MERIDIAN STORAGE, LLC
MERIDIAN STORAGE

FALCON RANCHETTES FILING NO. 2, NORTH HALF OF THE SOUTHEAST QUARTER OF SECTION 12
TOWNSHIP 13 SOUTH, RANGE 65 WEST OF THE 6TH P.M., COUNTY OF EL PASO
STATE OF COLORADO, MERIDIAN ROAD & OWL PLACE

CONSTRUCTION DRAWINGS

SF-23-XXX Add PCD File #VR239

C2.3

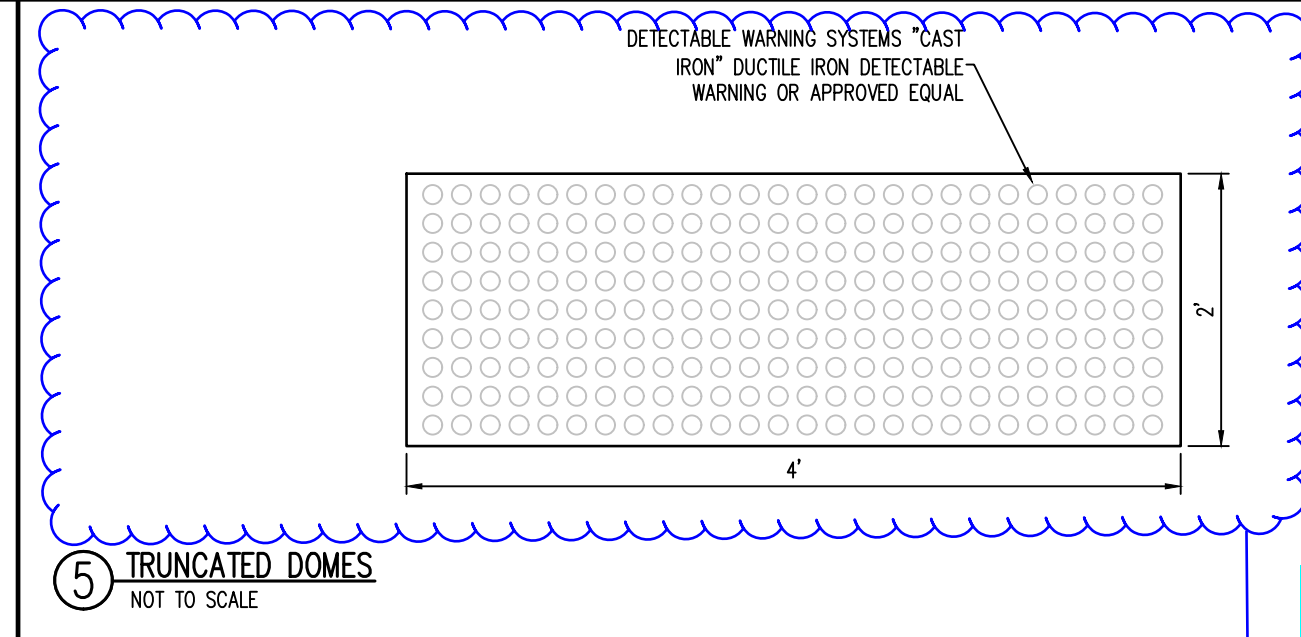
Use County detectable warning detail SD_2-42 from ECM Appendix F

⑦ MUTCD R1-1 "STOP" SIGN DETAIL
NOT TO SCALE

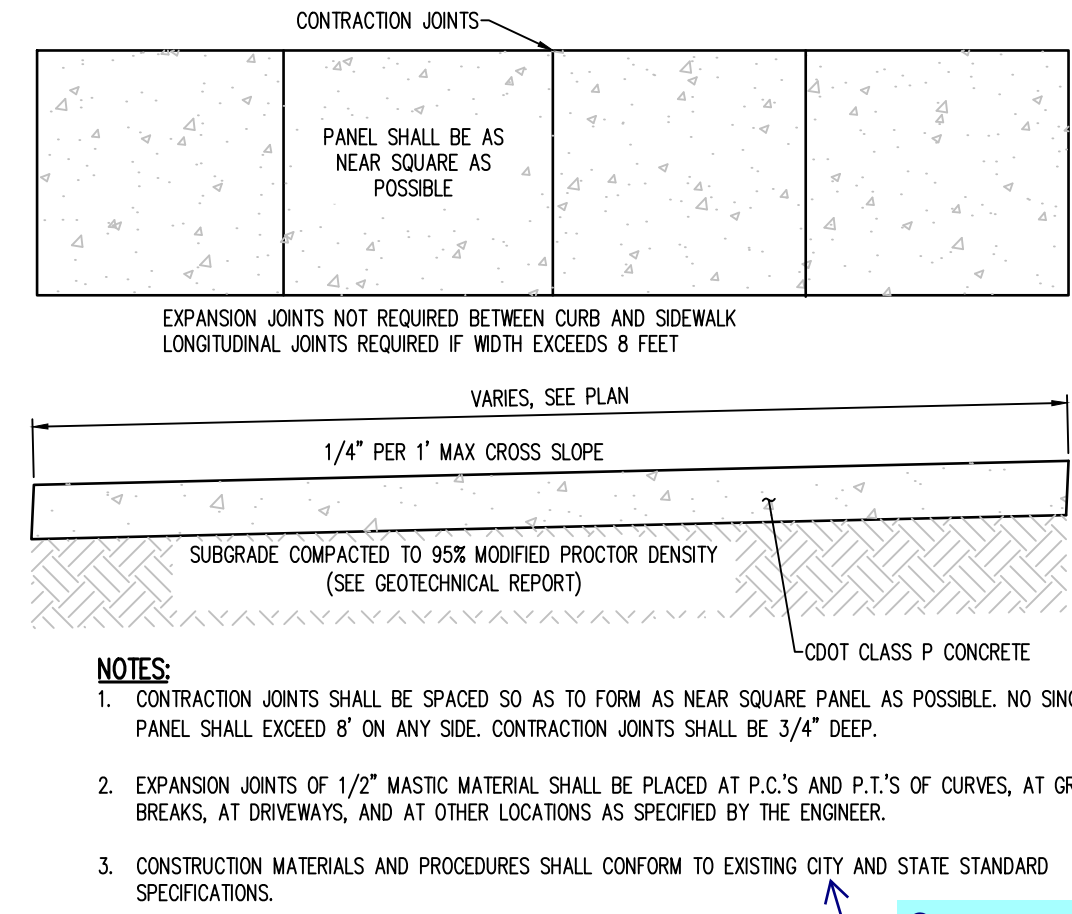
revise to 30"x30"

MERIDIAN PARK DRIVE (B) & STREET D - PUBLIC 60' R.O.W.
25 MPH DESIGN SPEED (LOCAL)
SCALE: 1"=20'

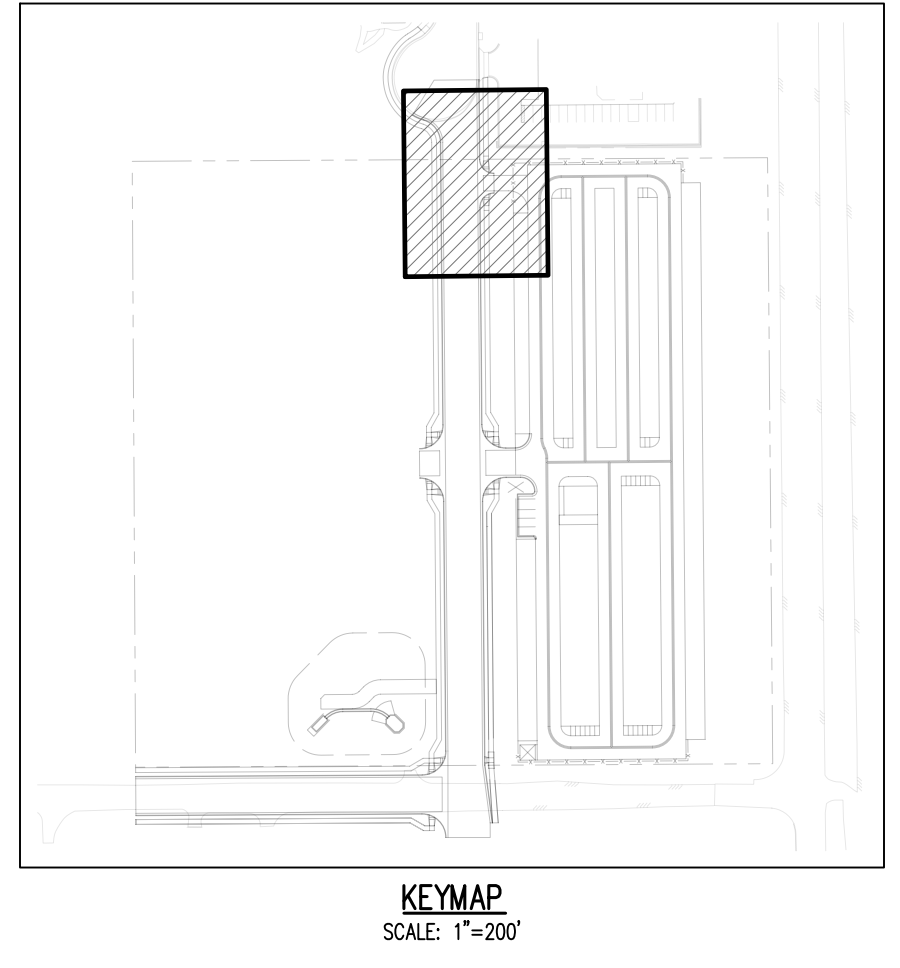
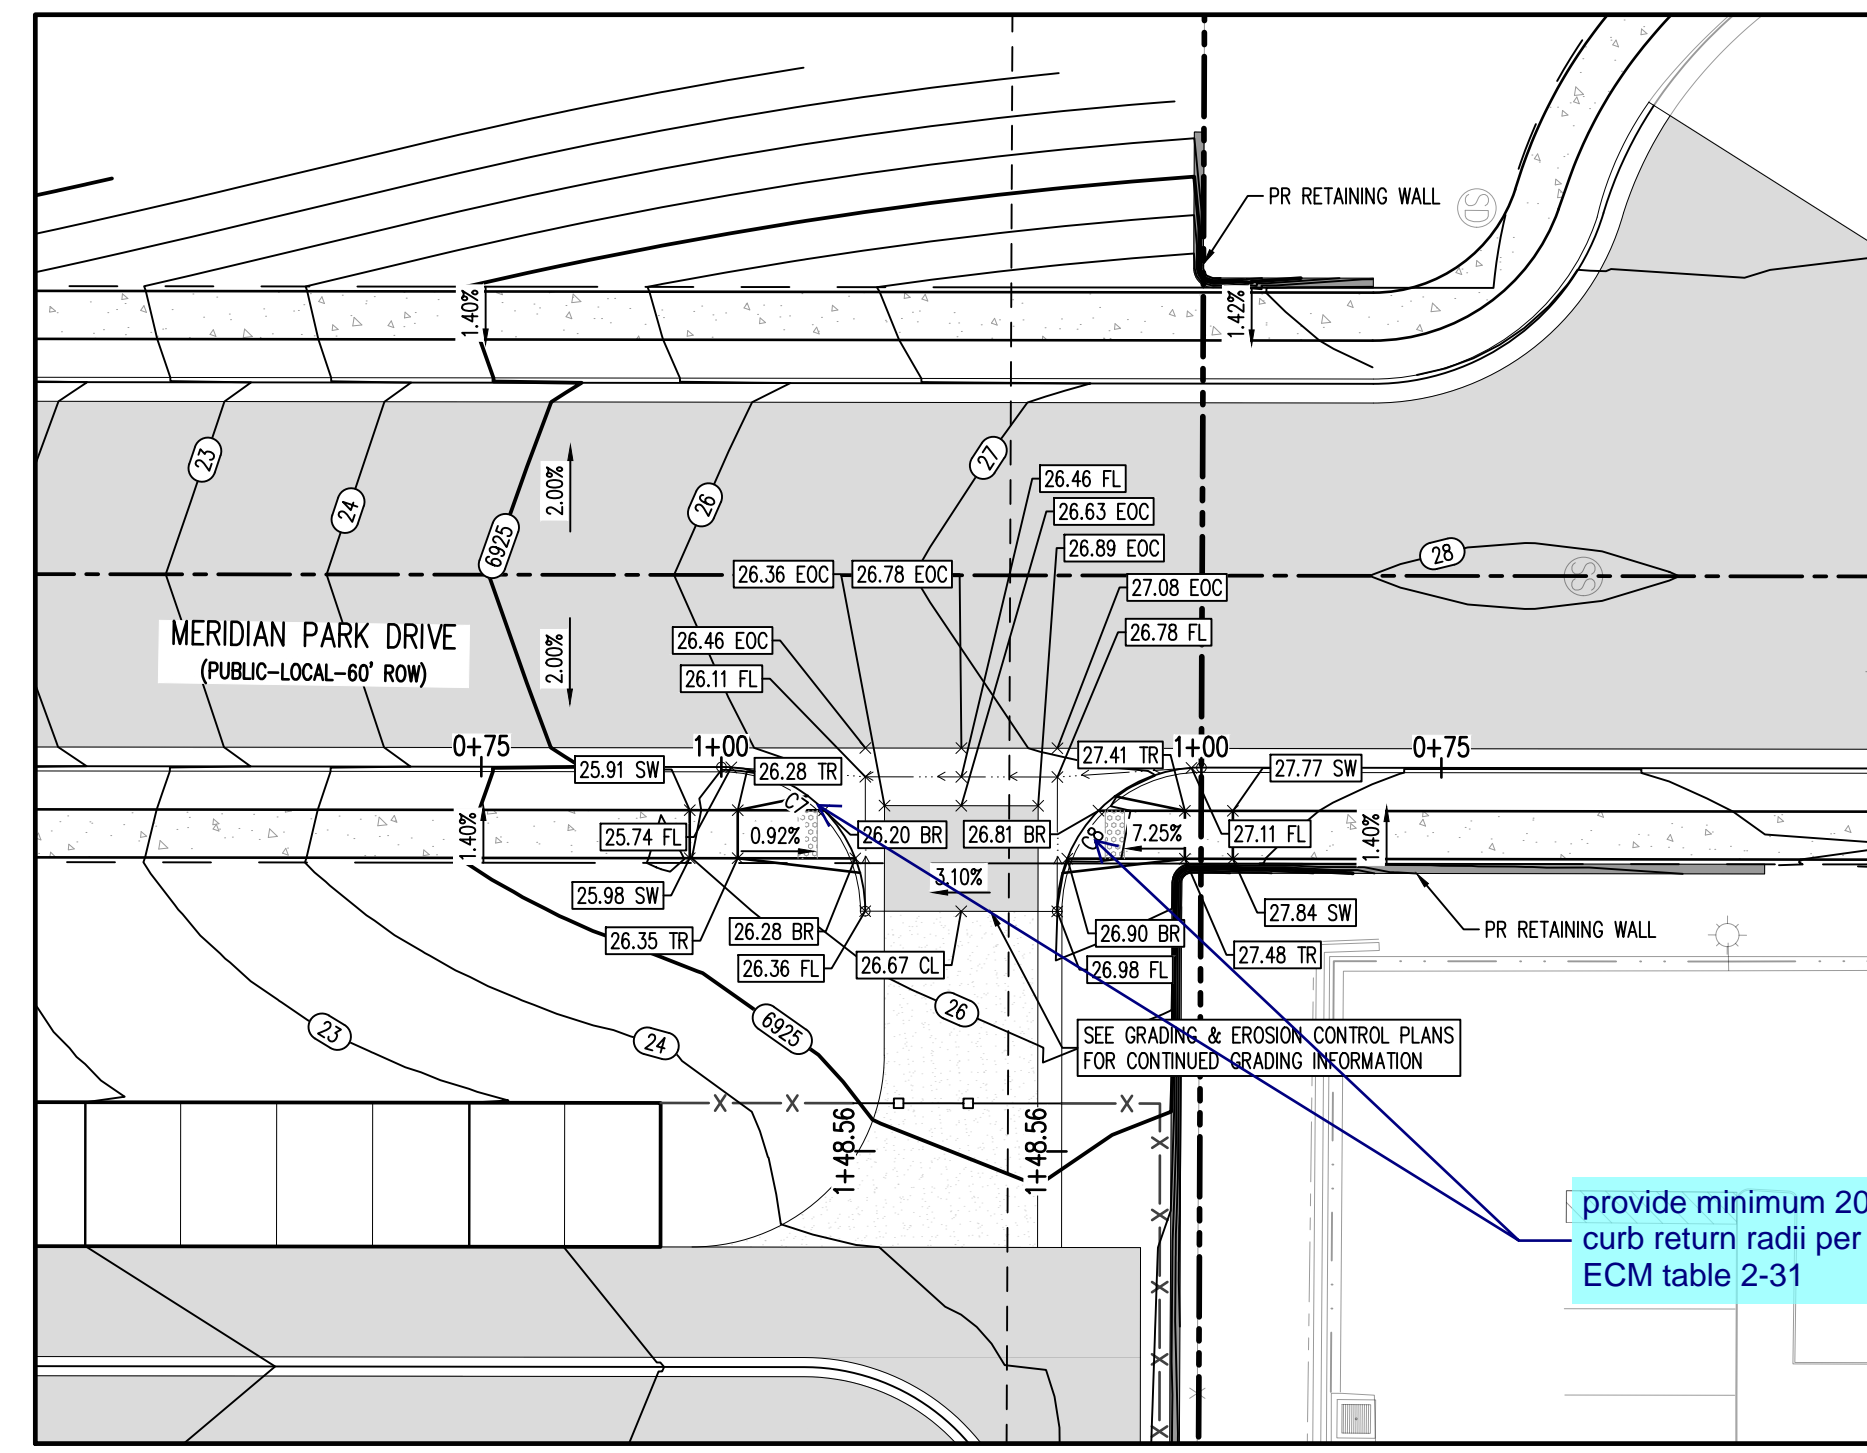
Call out and label all crosspans at all intersections and driveway access points along Meridian Park extension

STORM DRAIN PROFILE - LINE A (STA: 0+85 - 6+37.95)
 SCALES: HORIZONTAL 1"=20', VERTICAL 1"=4'

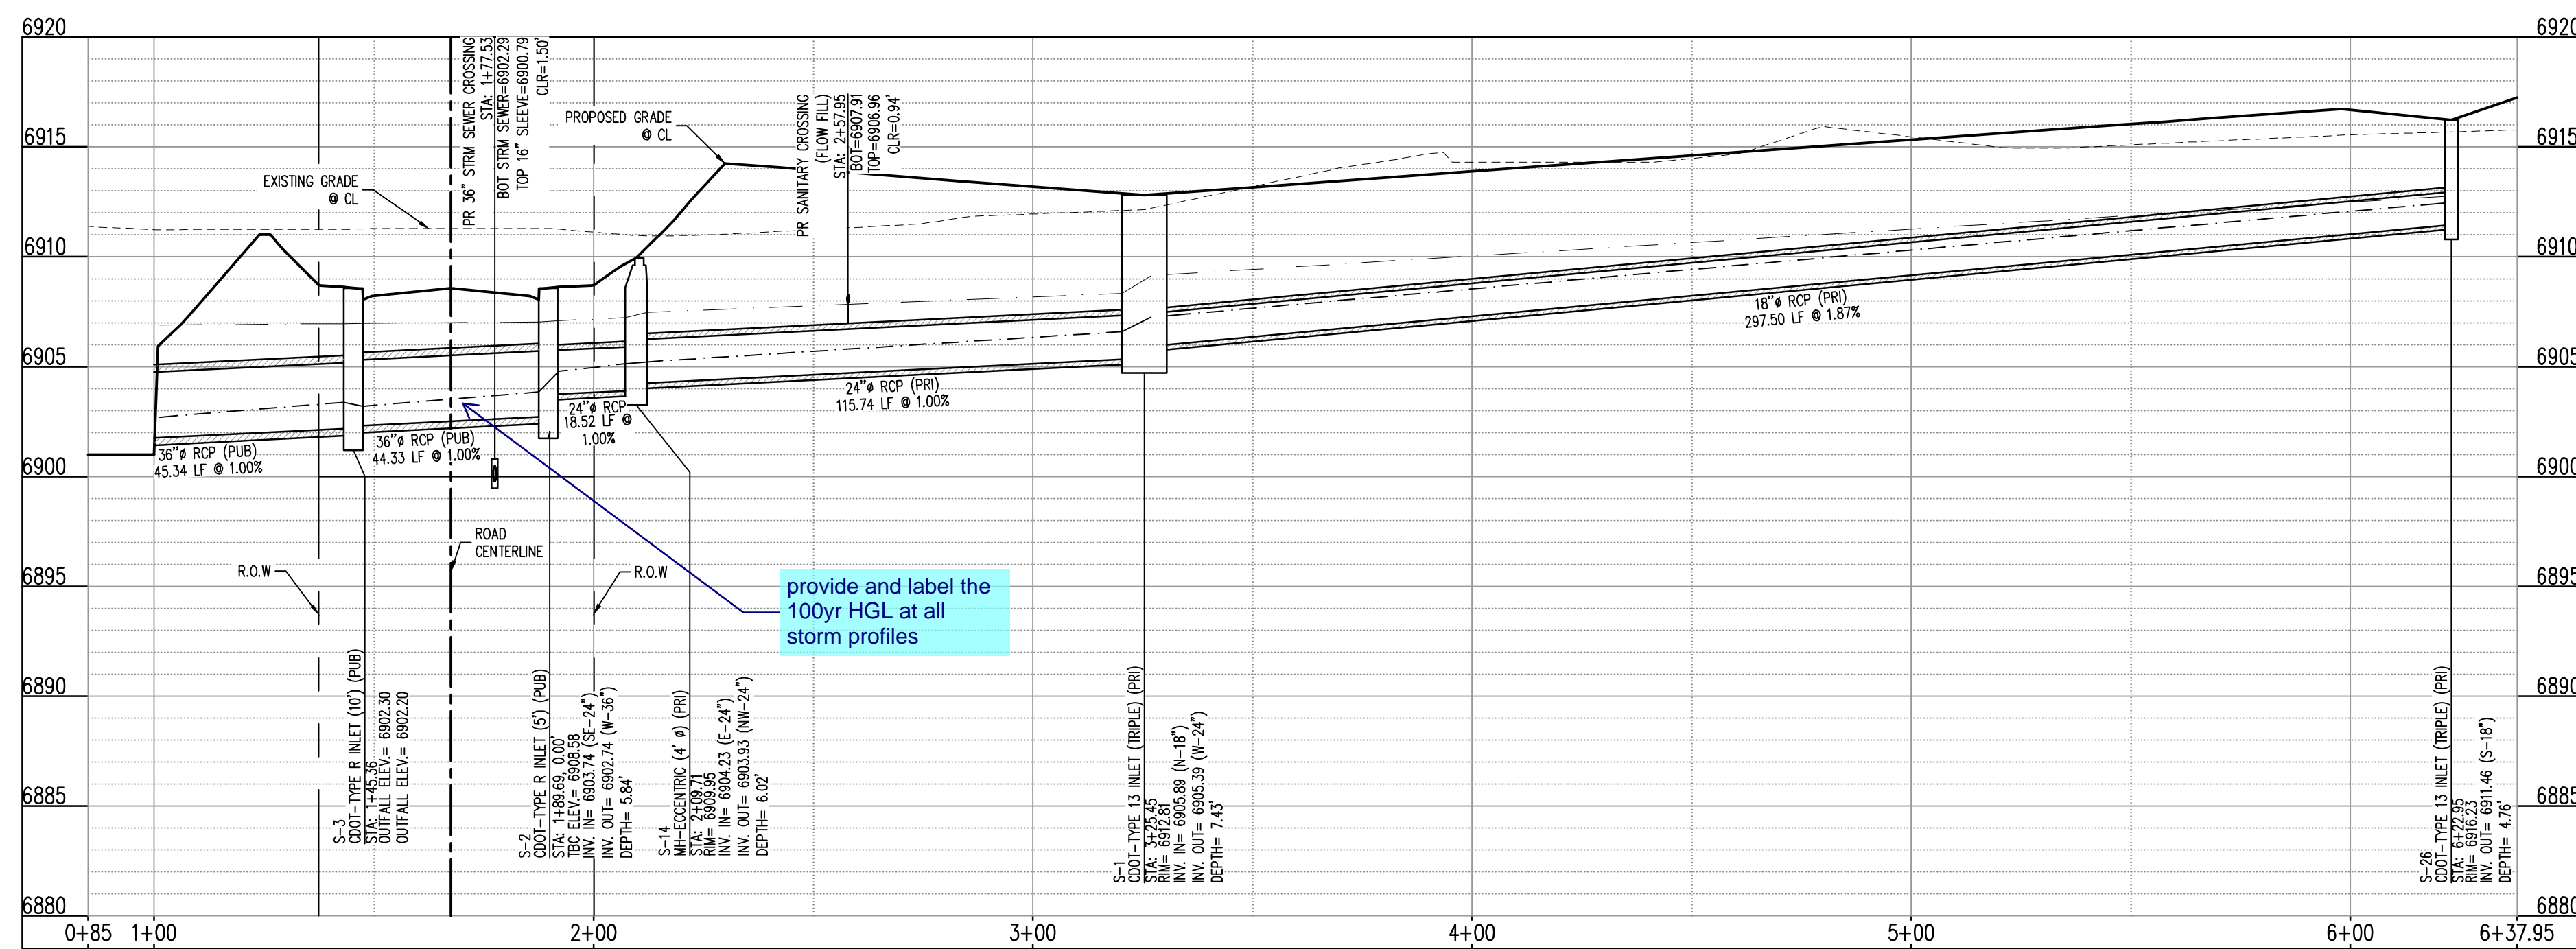
provide and label the 100yr HGL at all storm profiles

STORM DRAIN PROFILE - LINE C (STA: 1+00 - 2+06.65)
SCALES: HORIZONTAL 1"=20', VERTICAL 1"=4'

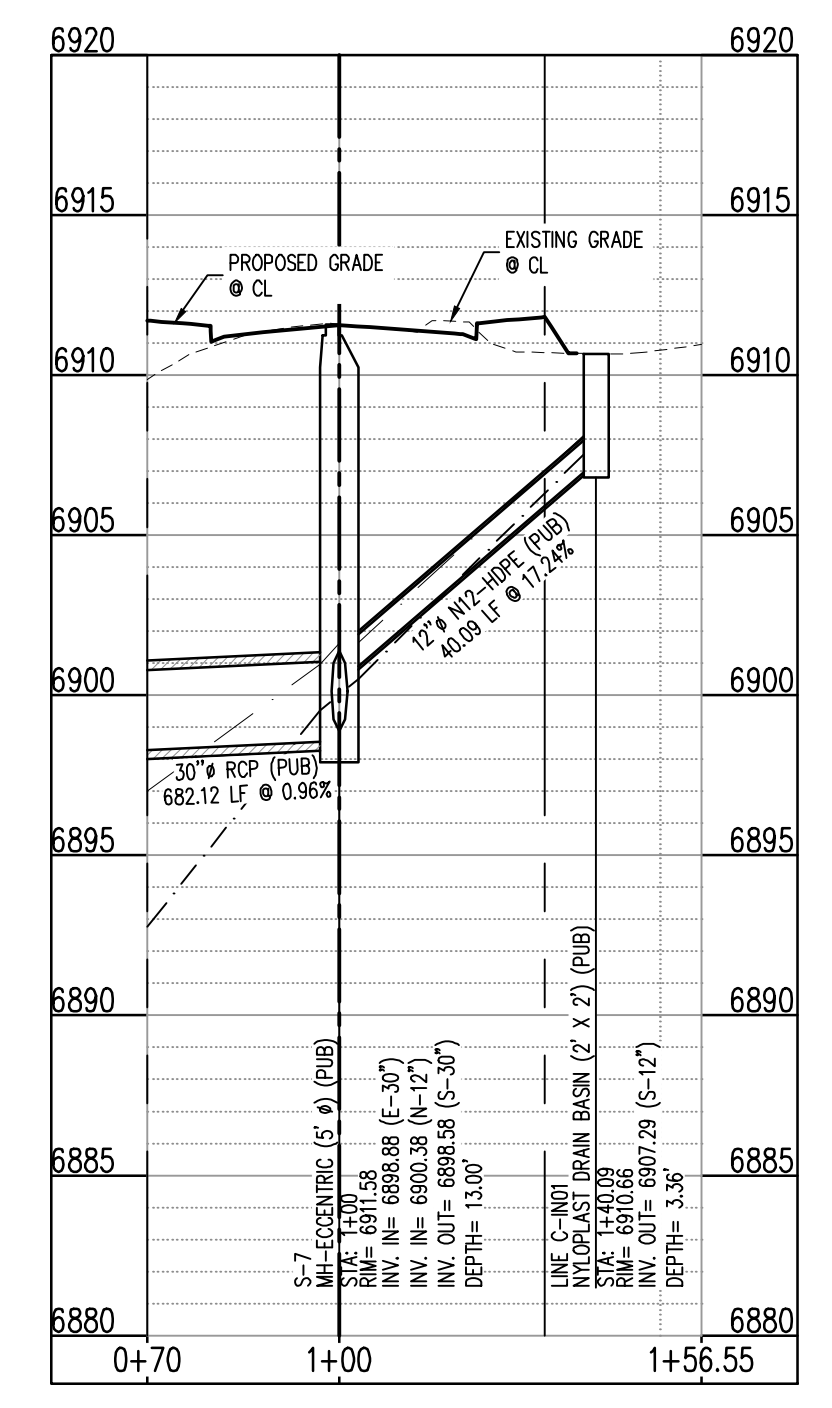
all storm sewers within the County's ROW are required to be RCP and a min. 18". See ECM 3.3.1.J.
